Access Compliance Report

Public Rights-of-Way

Intersection ID: 10674	Main Street: E_W_T_HARRIS_BV	Cross Street: MARKWAY_DR	Location: SW
ADA ID: DF57987D6E8B	Ramp Type: PerpDiag	Initial Pass/Fail: Pass	Overall Compliance: No
Severity Score: 10			
Codes/Mitigation Info/Possible Solution		Field Measurements/Component Compliance

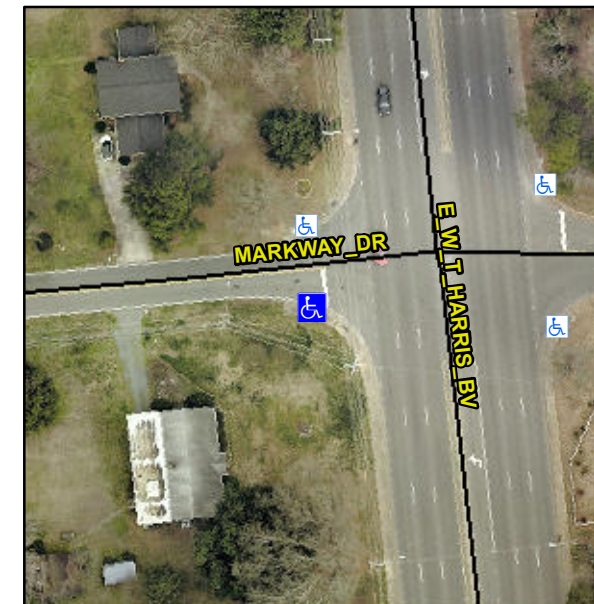
Not Found, R304.2.1, R304.2.2-Perp, R304.3.2-Para, R304.5.3, R305.2, R302.7

Remove & Replace Curb Ramp With Two New Directional Ramps or Equivalent.
